Subject: Oconee Nuclear Station  
Docket Nos. 50-269, -270, -287  
Proposed Revision to Technical Specifications  
Technical Specification Change # 95-03  
Response to Request for Additional Information #2

## ATTACHMENT 1

### RESPONSE TO REQUEST FOR ADDITIONAL INFORMATION

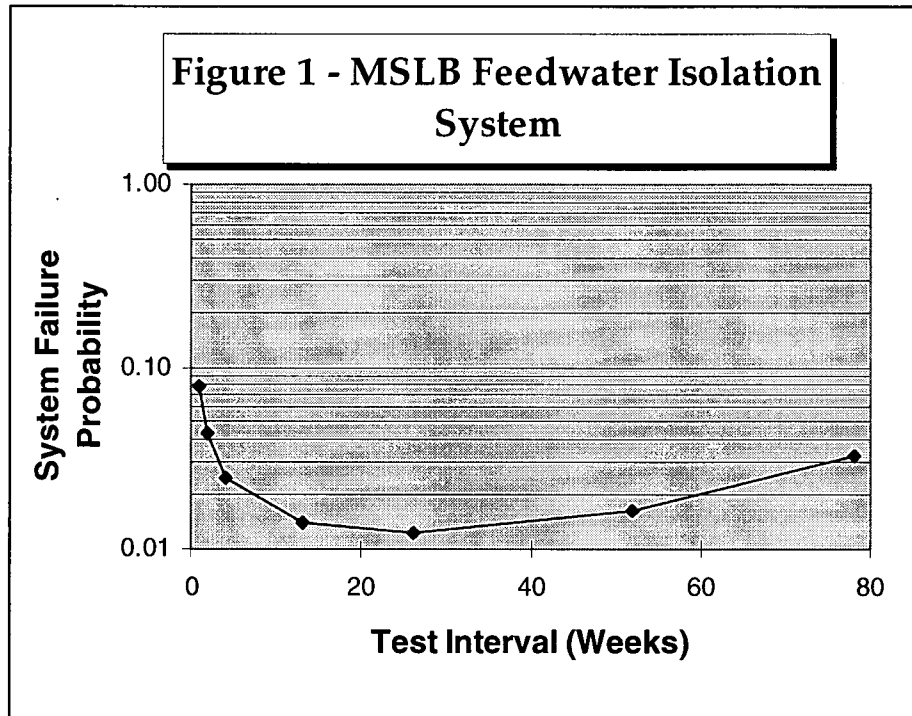
Attachment 3, page 13, para 2: Need supporting information from the study conducted to justify the claims made.

A study to determine the appropriate testing frequency for the circuit function verification test was conducted using standard PRA reliability analysis techniques. Specifically, this analysis entailed a fault tree analysis of functional failure of the system due to component failures, maintenance unavailability, or human error. Functional failure for this system is defined as a failure following a steam line break to isolate feedwater flow to the faulted steam generator. Seven different test cases were examined corresponding to seven different potential test intervals.

For each test case a different set of failure data was developed incorporating the maintenance unavailability and exposure time associated with the length of the test interval. The duration of each test is assumed to be 12 hours. The exposure time is simply one-half the mean time between tests, and is used to estimate the failure probability of certain components with time-dependent failure rates that can not be verified operable without testing. For components where a failure is indicated by alarms or can be detected by operators checking control board indications on "shift rounds", the mean unavailability was assumed to equal the hourly failure rate (/hr) times 18 hours (6 hours to discover plus 12 hours to repair). Table 1 below shows the corresponding maintenance unavailability and exposure time for each of the seven cases.

The analysis also considered common cause failure of similar redundant components and the potential for human errors that would render the system inoperable. The results shown in Figure 1 below show the competing influences of maintenance unavailability and system reliability.

Based on these results, the lowest "system" failure probability is achieved with a semi-annual test interval. While a semi-annual test frequency is optimal from a system reliability standpoint, a test frequency of every refueling outage provides a high level of reliability that is not significantly different than the semi-annual test frequency.
